Bulletin No.: 14636  
Date: April 2015

# Service Bulletin

**SUBJECT:** Special Coverage Adjustment – Reduced Engine Power / Accelerator Pedal Position Sensor

**MODELS:** 2009 Buick Lacrosse  
2009 Buick Allure (Canada)  
2009-2011 Chevrolet Impala

4089974

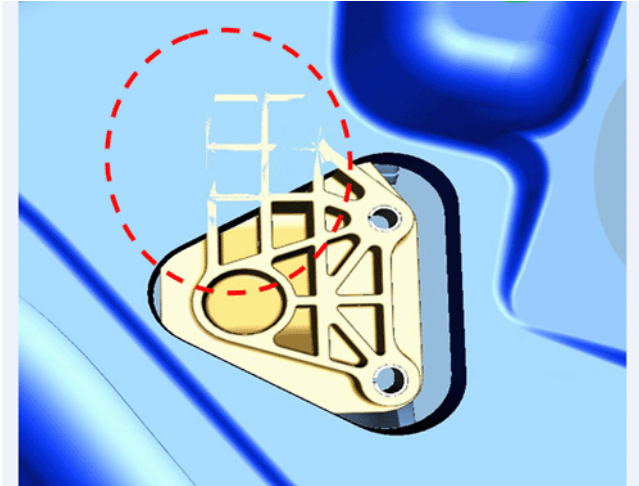
**Note:** The new replacement pedal (1) has a redesigned mounting bracket, which is shaped differently than the original pedal (2). Its installation requires cutting away a small portion of the insulator/sound dampening material under the instrument panel, to allow the new pedal to attach to the body.

4089975

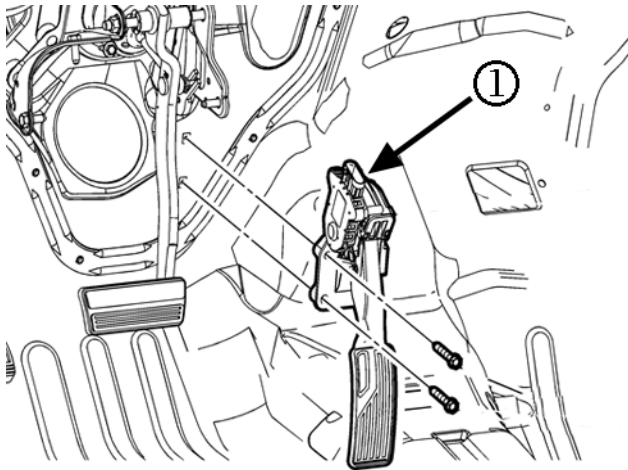
2. Using the new replacement pedal as a template, trace a line onto the insulator material that would designate the material to be removed due to interference on the new design part.
3. Use a sharp knife, or suitable cutting tool, to cut away the small amount of material.
